## New repair kit for SN 4220

## Repair kit brake shoe assembly with return springs

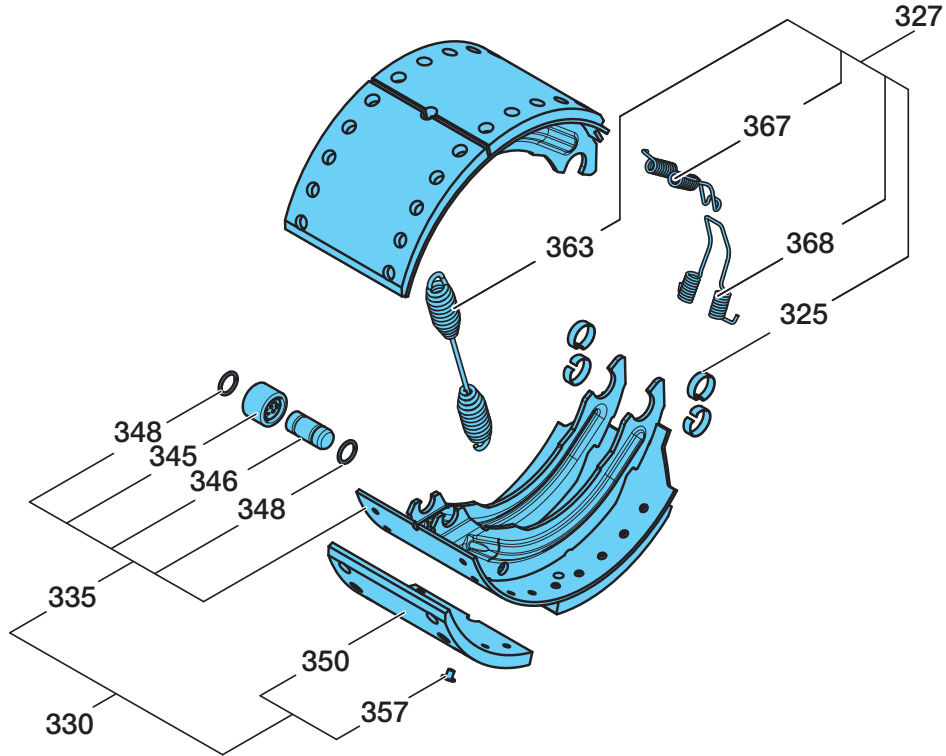
Following the successful launch of the ECO Drum generation of brake shoes in the SN 4218, the SN 4220 brake is now being changed over successively.

previously	=>	new
<b>Brake shoe assembly</b>		
05.091.27.82.1	=>	05.091.47.04.1
<b>Repair kit brake</b>		
09.801.02.38.0	=>	09.801.07.49.0
<b>Repair kit in mesh boxes</b>		
99.00.000.6.02	=>	99.00.000.6.23
99.00.000.6.03	=>	99.00.000.6.24

Repair kit SN 4220	
			previously 09.801.02.38.0	new 09.801.07.49.0
Pos.	Designation	Qty.		
327	Repair kit brake SN 42.. (return springs / ,C' clip)	1	09.801.02.44.0 Pos. 325, 363, 367, 368 incl. Pos. 315, 364 *	09.801.06.79.0 Pos. 325, 363, 367, 368
330	Brake shoe assembly, with lining	4	05.091.27.82.1 Pos. 335, 350, 357	05.091.47.04.1 Pos. 335, 350, 357

Shaped plates (03.167.23.09.0 / no. 315) and return springs (03.397.44.06.0 / no. 364) are no longer included in the new repair kit.  
Please order separately.

Requirement per axle:  
4x 03.167.23.09.0 / no. 315 and 8x 03.397.44.06.0 / no. 364
